Re: Request for Records
Freedom of Information and Protection of Privacy Act

VDZ-VIDAL ST.

DEVELOPMENT PROPOSAL APPLICATION – COMMENT SHEET

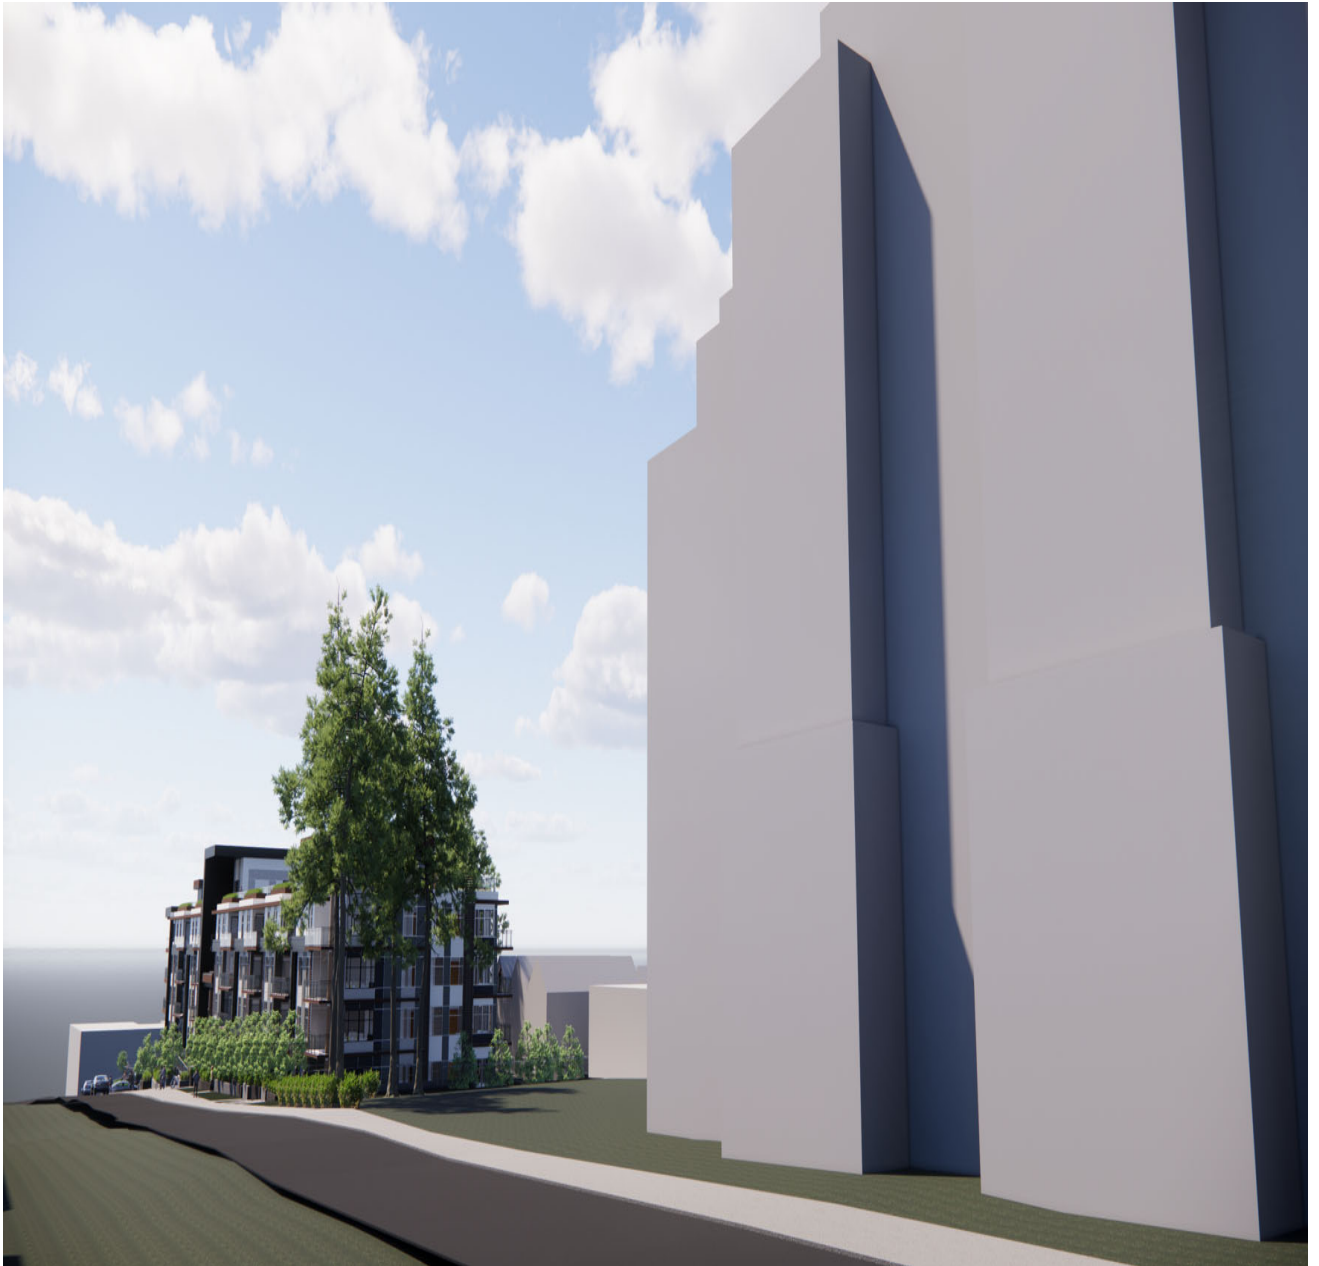
What is the setback from the northern property line to the wall of the actual buildings North East corner where it is closest to the property line.

The setback from the northern property line to the nearest corner of the building is 6.73m (22'-1").
